RE: **PETITION NO. 1678** - The Connecticut Light and Power Company d/b/a Eversource Energy petition for a declaratory ruling, pursuant to Connecticut General Statutes §4-176 and §16-50k, for the proposed West Devvon Junction to Devon Substation Rebuild Project consisting of the replacement and reconductoring of electric transmission line structures along approximately 2.17 miles of its existing 115-kilovolt (kV) 1483, 1545, 1580 and 1590 Lines right-of-way and approximately 0.17 miles of its existing 115-kV 1710 and 1730 Lines located on Eversource-owned property on each side of the Housatonic River Crossing between West Devon Junction in Stratford and Devon Substation in Milford, Connecticut, and related electric transmission line and substation improvements.

Eversource respectfully submits replies to interrogatories CSC-01 through CSC-45 for Petition No. 1678. This letter submittal provides an original and 15 copies of the responses.

XS-3 (Revised)

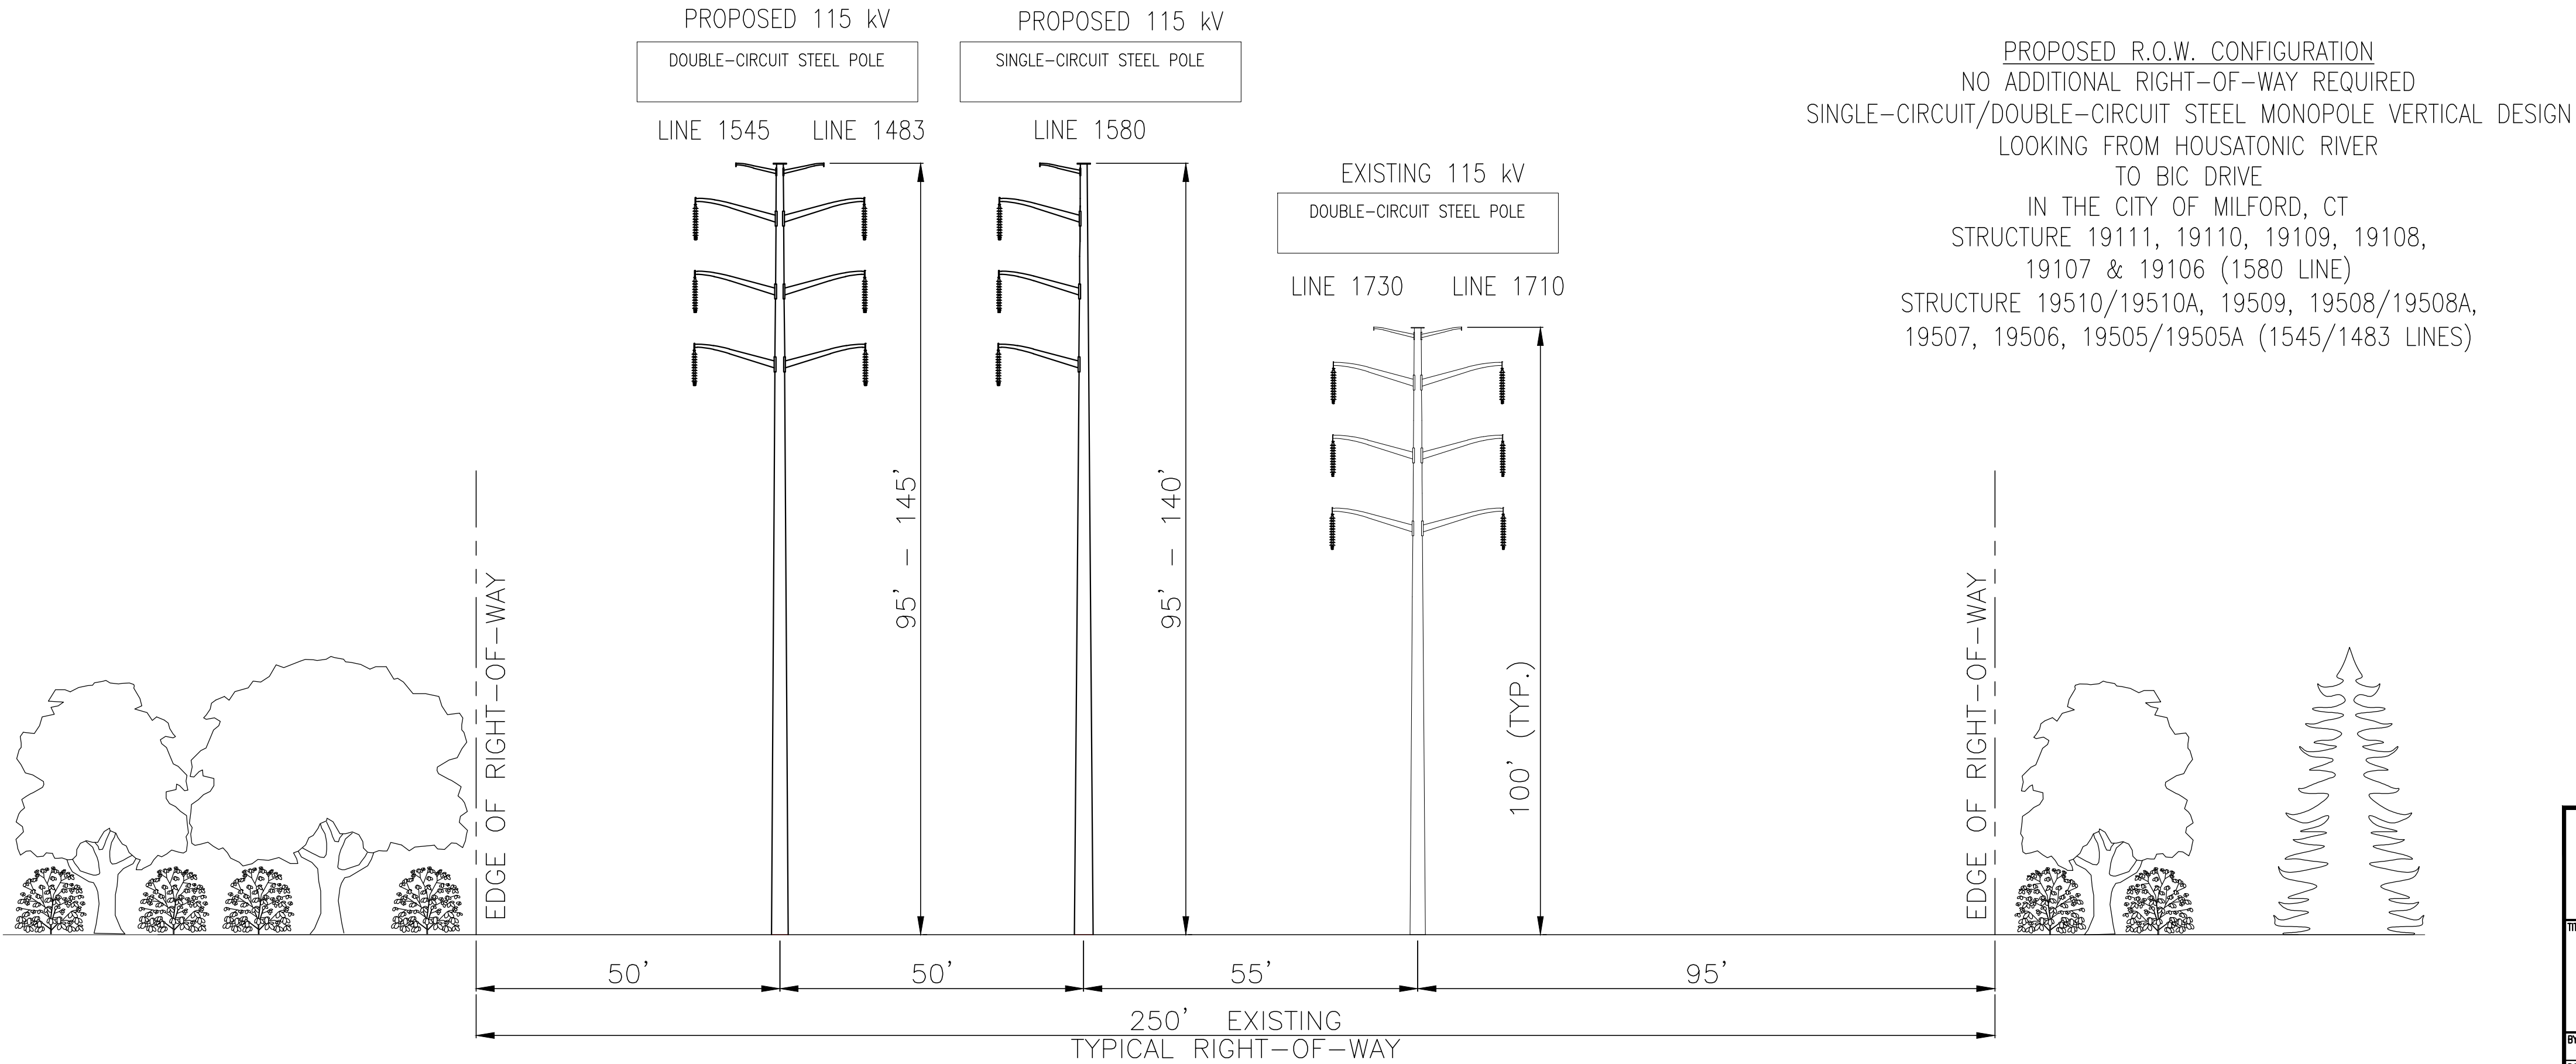
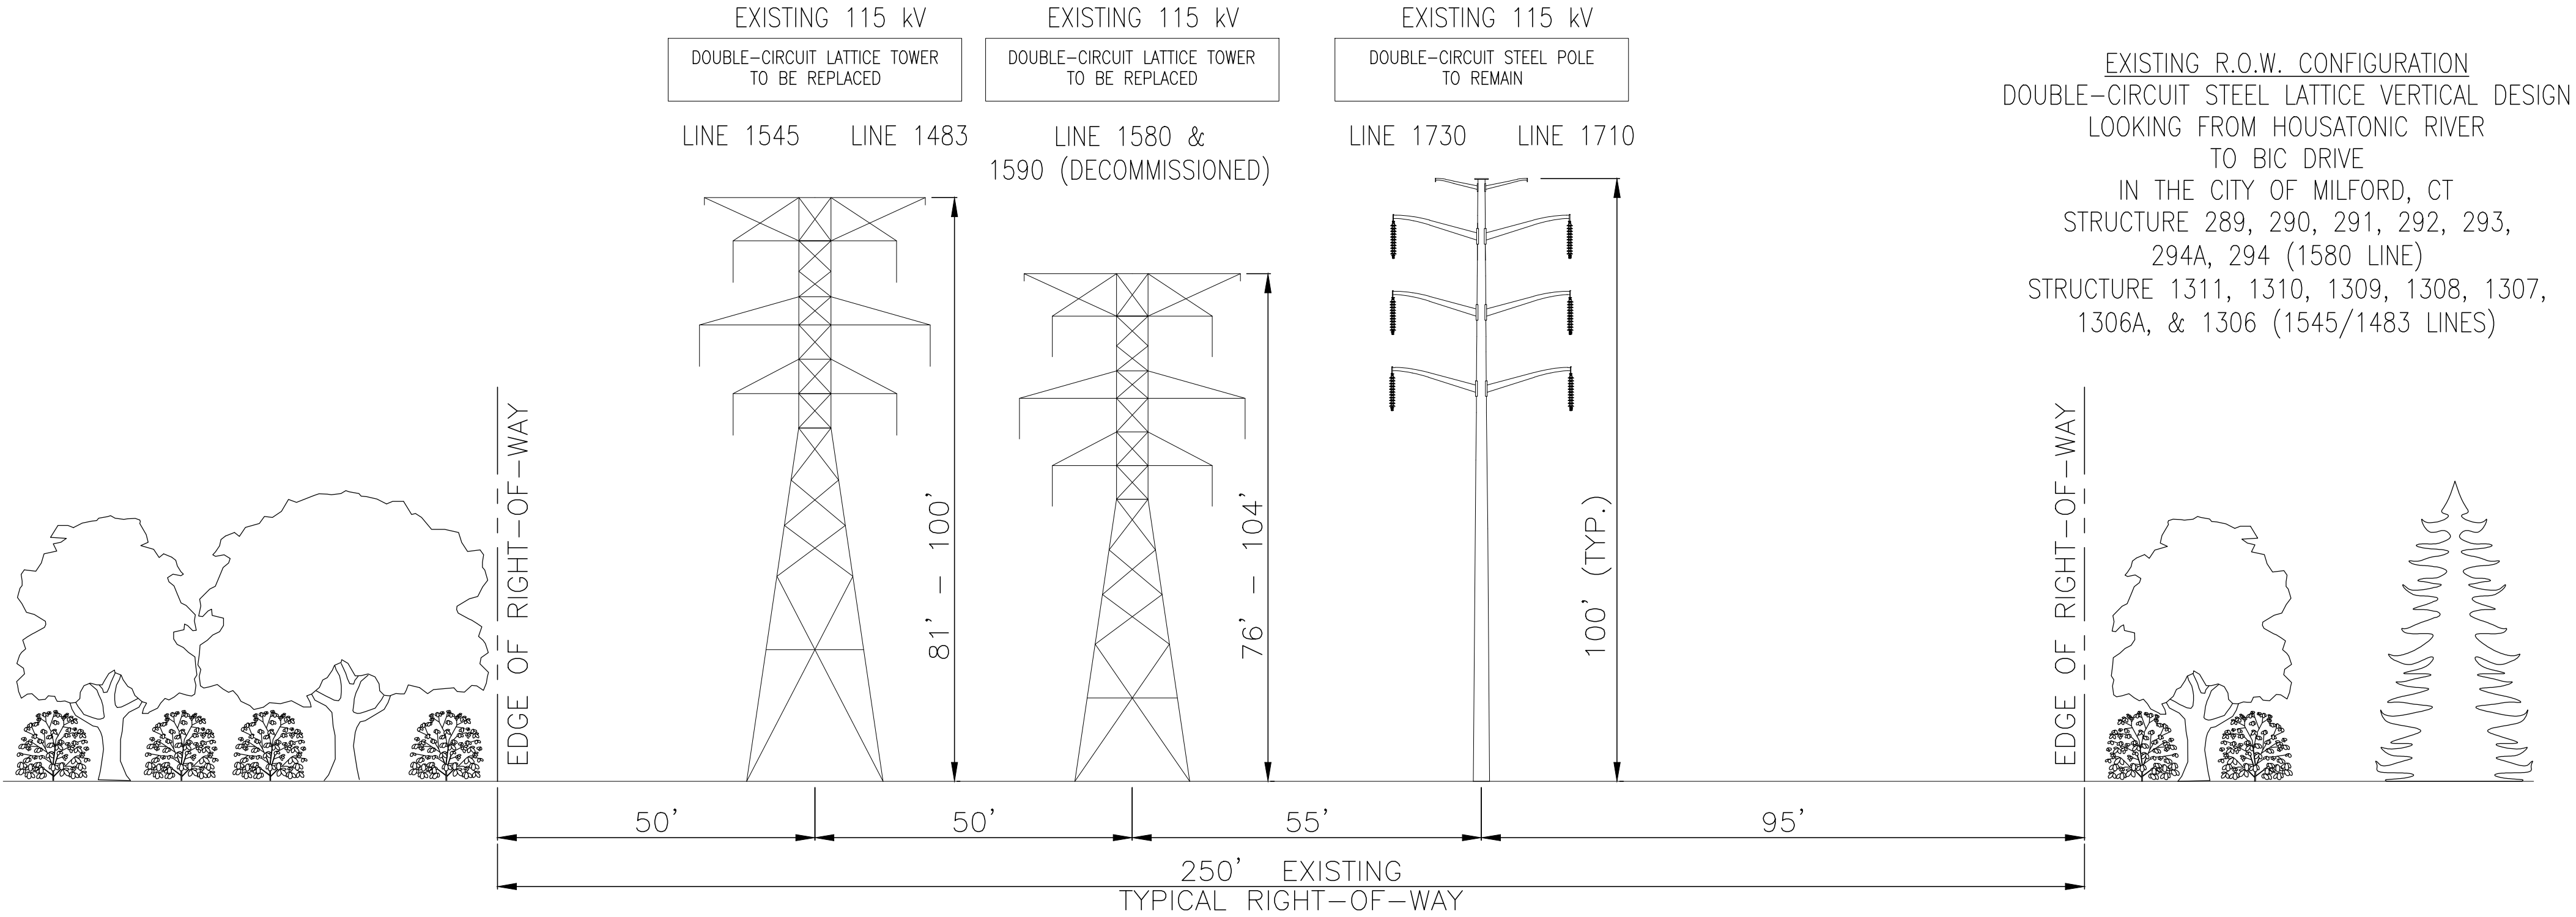
Question: Referencing Petition Attachment C – Sheet XS-3, why does the double-circuit steel monopole supporting the 1730 and 1710 Lines change from approximately 95 feet to 100 feet despite being identified as “existing” in the top and bottom of the sheet? Explain. Submit a corrected sheet if necessary.

Petition Attachment C – Sheet XS-3 had an error in the labeled height of the existing structures carrying the 1710/1730 lines. The typical existing structure height in this section of the Project area is 100 feet. A corrected Sheet XS-3 is attached, CSC-001\_Attachment Q41.
